Staff Report

Meeting Date: October 8, 2018

Project Name: Floodplain Use by Special Exception 6705 S. Santa Fe Drive

Case Number: ENG17-0007

Figure 3

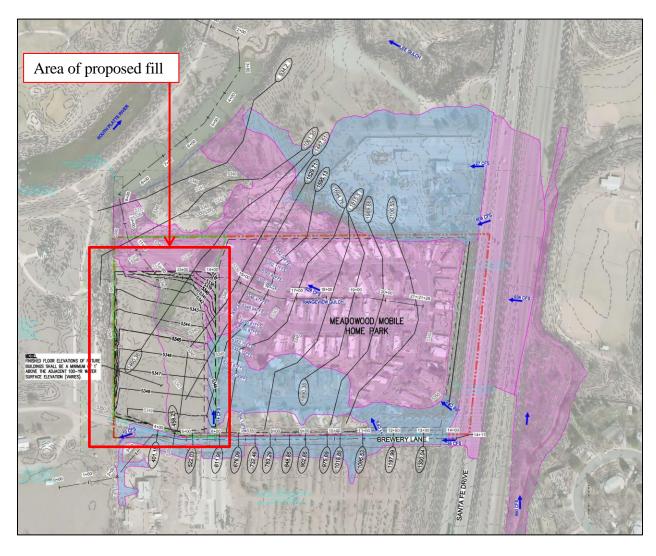
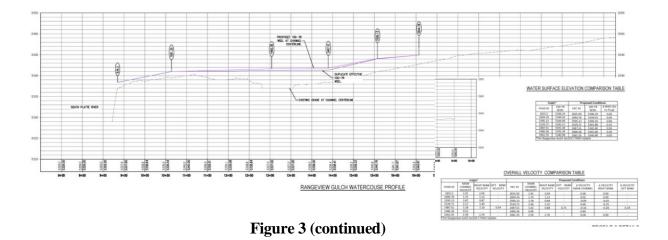
The request is to modify the site by placing fill material in the southwest portion of the floodplain. This fill will elevate this portion of the property above the floodplain elevation. Figure 3 shows the site plan with the proposed fill. The Floodplain Use by Special Exception requires detailed hydraulic analysis to determine the feasibility of modifying the existing floodplain. If approved, the applicant will continue with final civil engineering construction drawings to be reviewed by staff

Since Rangeview Gulch does not have a delineated floodway (it is not uncommon to have a floodplain but not a studied and delineated floodway), only subsection (D)(4) of Section 10-6-6 applies. This provision limits the encroachment that can occur in the floodplain, similar to that with a designated floodway. The maximum increase in 100-year water surface elevation is restricted to +0.5°. This application has changes in water surface elevation with a maximum of +0.5°.

Section 10-6-8(B) outlines specific requirements for development within floodplains. No buildings are proposed with the current application, but the applicant has committed to compliance with stated regulations at a future time with subsequent building permit applications and FHAD update. The proposed grading plan demonstrates compliance with subsection (B)(2)(a) by indicating proposed building footprint elevations will be 1.0' above the proposed adjacent 100-year water surface elevations. Elevations will be verified with future updates to design and analysis. Subsection B(2)(d) also applies to this application, because fill material is being placed within the existing floodplain to elevate the ground. The fill placement does not adversely affect efficiency of the watercourse (1). The placement is the minimum required to flood-proof future structures adjacent to the floodplain (2). Because there is no floodway, item (3) does not apply. The fill materials will be adequately protected from erosion by grass cover or riprap, or an equivalent as determined by engineering analysis in final design (4), and the Use by Special Exception will not result in increased flood heights or threats to public safety, public expense, create nuisances, nor conflict with other laws or ordinances (5). The increased flood heights are negligible and are located below the floor elevations of mobile homes. Increased flow velocities are also negligible. Flood risk is often evaluated based on a depth-velocity product, where if the product exceeds nine feet per second, there is risk to an adult standing in that flood water. All increases in velocity and/or depth have depth-velocity products well below nine feet per second. (Source: Urban Flooding: Flood Safety Guidelines for Depth and Velocity. www.overlandflood.com). The Dam Safety Program of the Colorado Division of Water Resources uses a criteria of d*v=7 as a threshold when assessing risk associated with flood waters. This project also has depth-velocity products less than seven.
